P05	05/04/24	Tender Addendum 2	ADT	AT	CSJ
P04	05/12/23	Tender Issue	ADT	AT	CSJ
P03	21/11/23	Tender Issue	ADT	AT	CSJ
P02	31/10/23	Tender Issue	ADT	AT	CSJ
P01	29/09/23	Draft tender issue	ADT	AT	CSJ
P00	11/08/23	Draft for comment	ADT	AT	CSJ
Revision	Date	Description	Drawn	Checked	Approved

Project: BALTIC HUB T5 OFFSHORE WIND TERMINAL PROJECT

Drawing Title: EASTERN INTERFACE WALL SECTION 2

Designing company	HaskoningDHV Polska Sp. z o.o. ul. Dzielna 60 01-029 Warszawa	Drawn	ADT	Checked	AT	Approved	AT
Date	11/08/23	Scale	1:100	SUITABILITY	S4	REVISION	P05
Drawing number	PC1063-RHD-T5-OW-DR-CM-3004

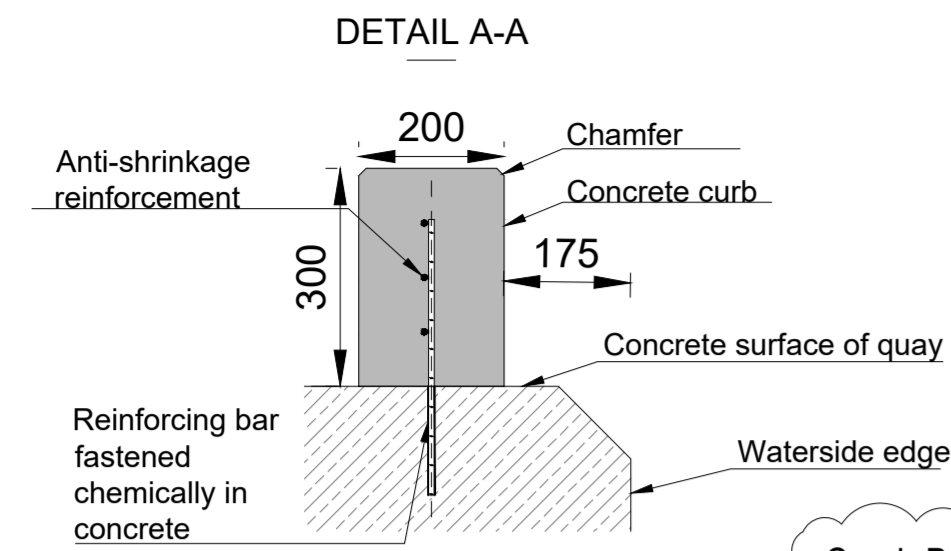
REV05

Please see Note 5 and 6 for description for soil descriptions shown

REV05
